ECN/PCN No.: M1194

For Manufacturer			
Product Description: Low Profile Shielded SMD Chip Power Inductor	Abracon Part Number / Part Series: ASPI-0615FS Series	<input type="checkbox"/> Documentation only <input checked="" type="checkbox"/> ECN <input type="checkbox"/> EOL	<input checked="" type="checkbox"/> Series <input type="checkbox"/> Part Number(s)
Affected Revision: D	New Revision: E	Application: <input type="checkbox"/> Safety <input checked="" type="checkbox"/> Non-Safety

7.0 Mechanical and Material Information 1 (Effective Date: before 1/18/2012)

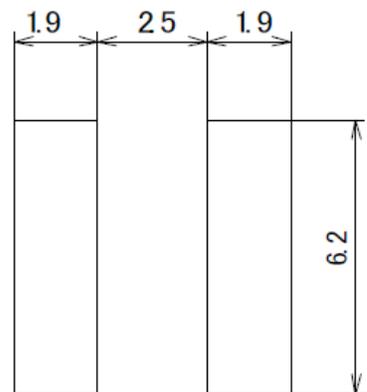
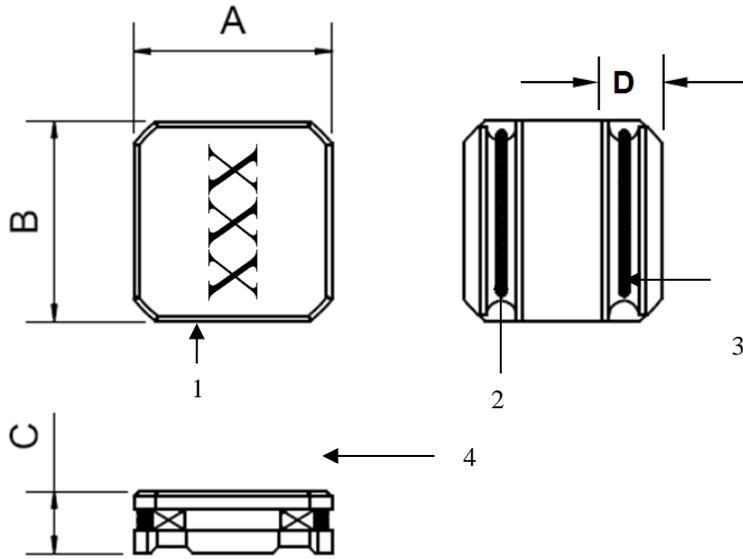
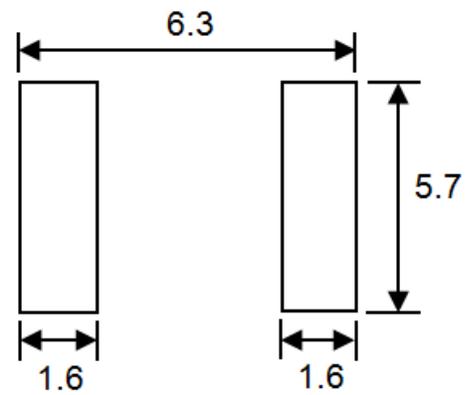
Production line mechanical dimension differences documented. This is a follow up ECN of M1114 where mechanical dimensions update were erroneously missing.

The mechanical dimensions have changed slightly and will not adversely affect the products performance, form, fit or function. These should be considered cosmetic changes only.

A	B	C	D Typ.
6.0±0.2	6.0±0.2	2.0±0.2	1.50
